Technical Announcement
IABG, DELTA ELECTRONICS, INC

Product	DVP Series PLC	Applicable Model	DVP-EC3	Confidentiality Level	<input checked="" type="checkbox"/> General <input type="checkbox"/> Classified <input type="checkbox"/> Top secret
				ECN No.	N/A
Published by	PLC BU	Publisher	Andy Due	Publication No.	134A-P-EC3-TAN01-EN
				Date of Publication	April 16, 2015
Published to	Taiwan Sales, Product Manager, DGC, DEU, DPR, DES, DEJ

Object: The heights of the bases of DVP-EC3 series PLCs are increased.

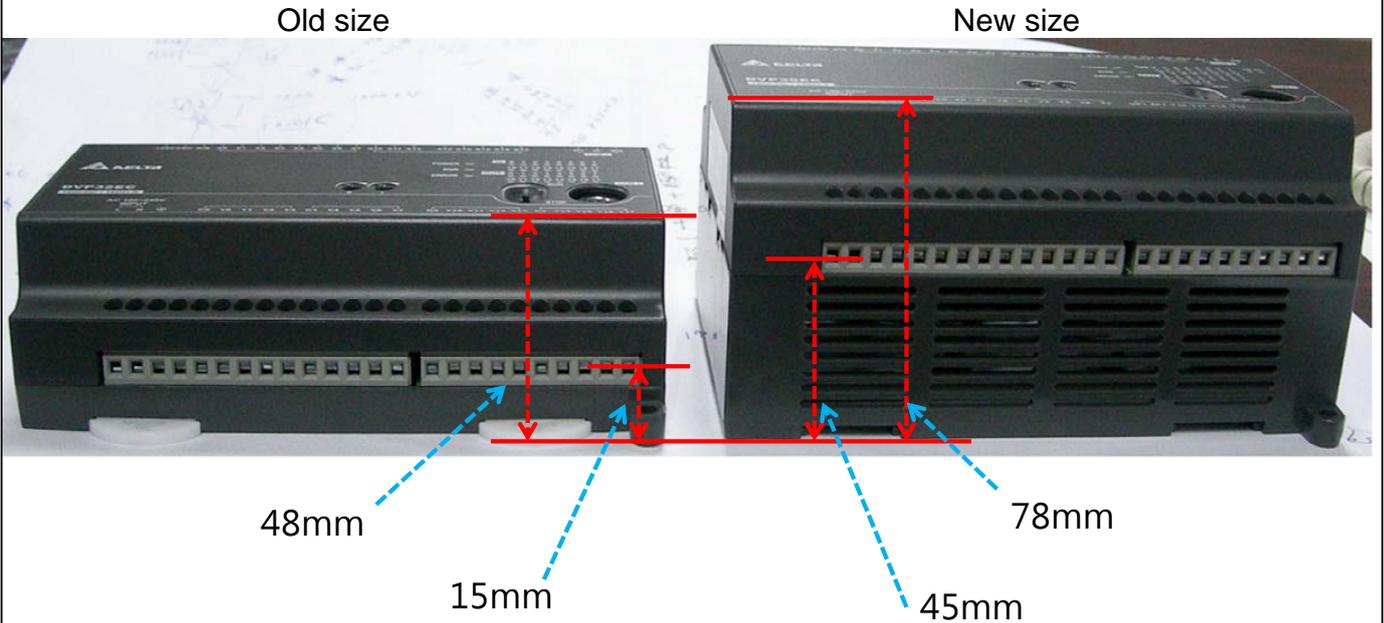
1. To meet customers' requirement of the depth for wiring terminals, the heights of the bases of all DVP-EC3 series PLCs are increased by 30 mm.
2. The comparison between the old size and the new size is shown below.
